DRAFT DECISION
Ausgrid
Distribution determination
2019–24

Attachment 5 – Capital
expenditure

November 2018

Figure B.2.1 Ausgrid's historical and forecast augex (\$2018–19)

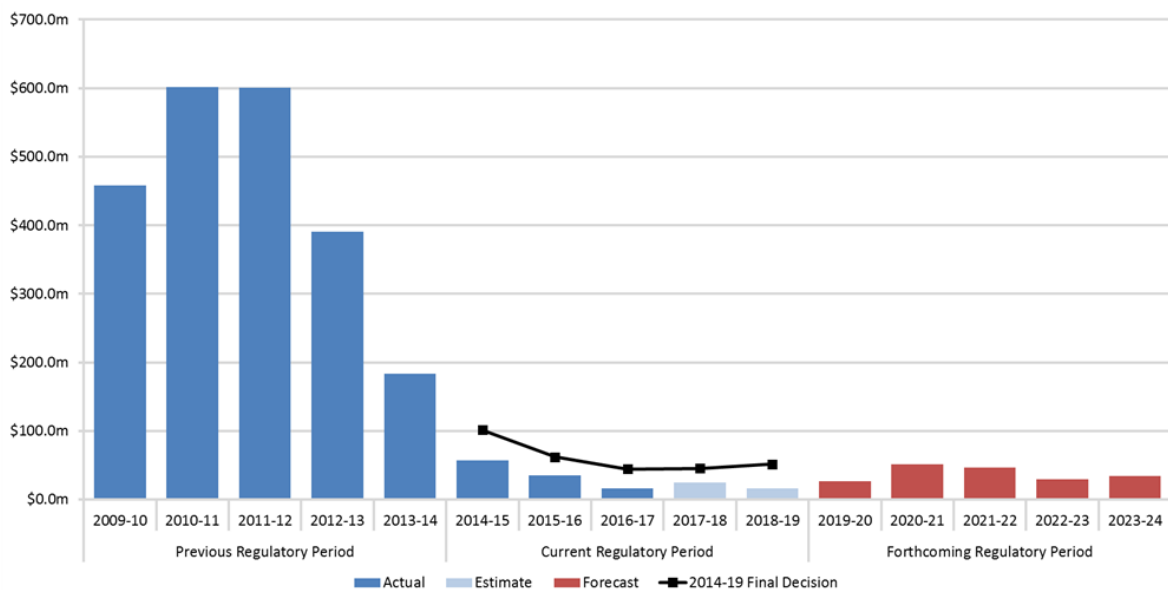
Figure B.2.1 indicates that Ausgrid has forecast an increase in augex in the 2019–24 regulatory control period. Average annual augex is forecast to increase from \$30.0 million per annum in the 2014–19 regulatory control period to \$37.8 million in the 2019–24 regulatory control period. Over the 2014–19 period, Ausgrid expects to underspend the allowance of \$305.4 million by \$155.3 million or 51 per cent.

While Ausgrid has forecast an increase in augex relative to the 2014–19 regulatory control period, it remains well below the levels of expenditure incurred during the 2009–14 regulatory control period. Ausgrid submitted that the shift to lower growth capex reflects its ability to draw on the capacity of past investments to meet new growth.⁵² We note that the repeal of deterministic planning criteria in NSW was a major factor for the capex reduction in 2014–19 regulatory control period.

Figure B.4.2 Ausgrid's historical vs forecast modelled repex (by asset group) (\$2018–19, million)

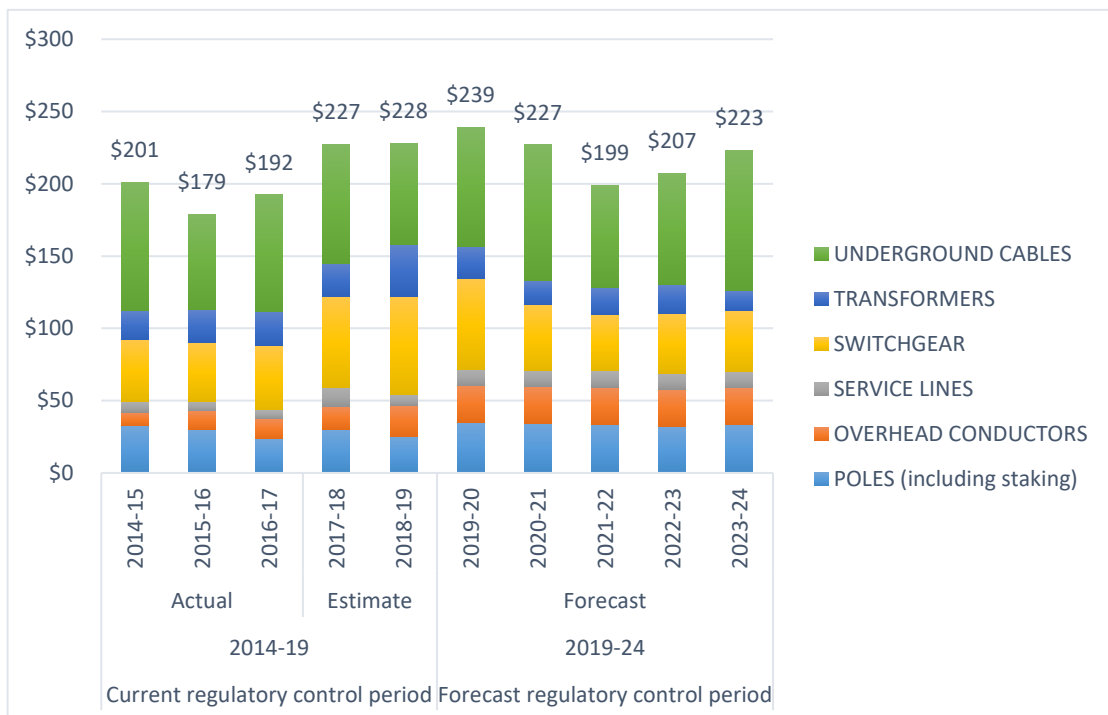
However, figure B.4.2 demonstrates that the fifth year of the current period is significantly higher than Ausgrid's revealed level of repex over the preceding years. We therefore sought to ensure that this higher level of repex, which carries on into the forecast period, was sufficiently justified. However, Ausgrid did not sufficiently justify the increases in both repex and replacement volumes to these higher levels for the 2019–24 regulatory control period in its proposal and in subsequent information request responses.

Figure B.4.2 highlights a similar trend to the total historical and forecast repex trend outlined in figure B.4.1. Ausgrid’s actual modelled repex in the first three years of the current period is moderately lower than its estimate for the last two years of the current period and the 2019–24 forecast period. Ausgrid is forecasting increases in all asset groups except service lines and transformers. Overhead conductors, switchgear, underground cables and poles were therefore key focuses of our bottom-up assessment, which is discussed below.

Figure B.4.3 Four modelled scenarios vs Ausgrid's modelled repex forecast (\$2018–19, million)

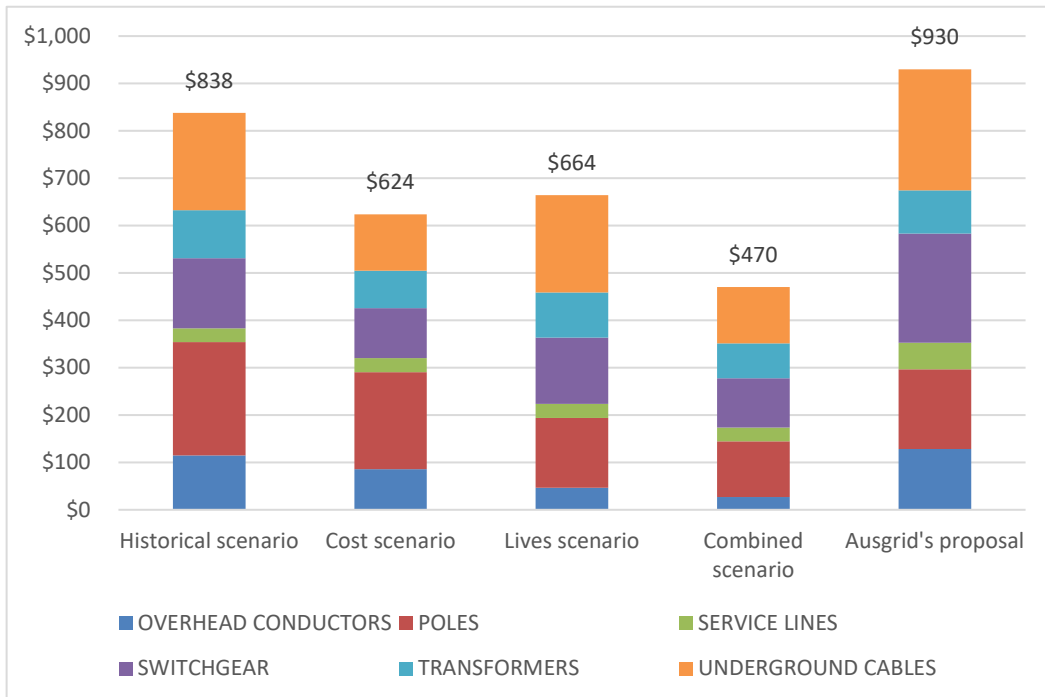
Figure B.4.3 outlines Ausgrid’s proposed modelled repex compared with our four scenarios. The ‘repex model threshold’ is the ‘lives scenario’. Ausgrid’s proposal is \$266 million (40 per cent) greater than the repex model threshold. Nuttall Consulting compared Ausgrid’s repex forecast with repex model outcomes using previous assessment approaches. It revealed that Ausgrid’s forecast was likely to be 7 per cent above a possible alternative based on the repex model.¹⁵⁴ However, this analysis relied on outdated analysis techniques and input information. Our results, based on more recent unit cost and asset replacement data, therefore differ significantly from the results outlined in Nuttall Consulting’s advice.

Figure B.4.3 highlights that Ausgrid’s proposal for modelled repex is significantly higher than our results for overhead conductors, service lines, switchgear and underground cables. Ausgrid’s forecast for poles is only slightly higher than our modelled results, while its forecast for transformers falls slightly below the modelled threshold. We have used these results to identify asset groups and categories to examine in greater detail, and to help inform our bottom-up assessment.

Figure B.5.3 Ausgrid's total actual/estimated and forecast buildings and property capex (\$2018–19, million)

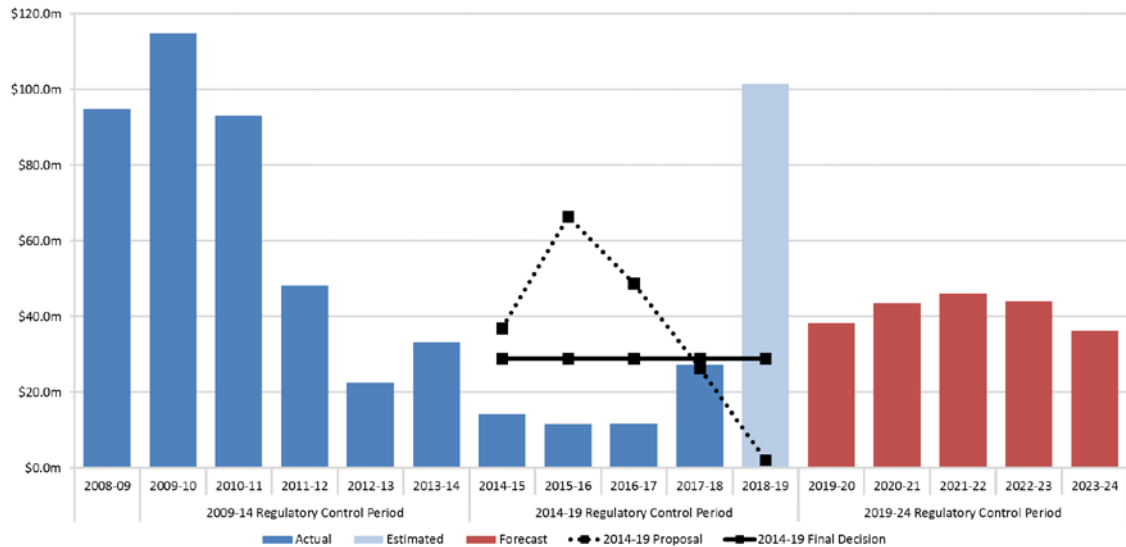
Figure B.5.3 indicates that Ausgrid has significantly reduced buildings and property capex from 2008–09 to 2011–12 levels. Over the subsequent six years (2012–13 to 2017–18), Ausgrid has incurred on average \$20 million per year on buildings and property capex. Ausgrid has submitted that this reflects a "period of rationalisation, with limited capital expenditure and the disposal of a number of sites."²⁵⁵

As shown in figure B.5.3, Ausgrid has significantly underspent relative to proposed and allowed capex over the first four years of the current period. In determining our final decision for the current period, we concluded that "based on an observed historical pattern of project deferrals and re-scoping, we consider it likely that a proportion of projects proposed by Ausgrid for the 2014–19 period will again be re-scoped, deferred
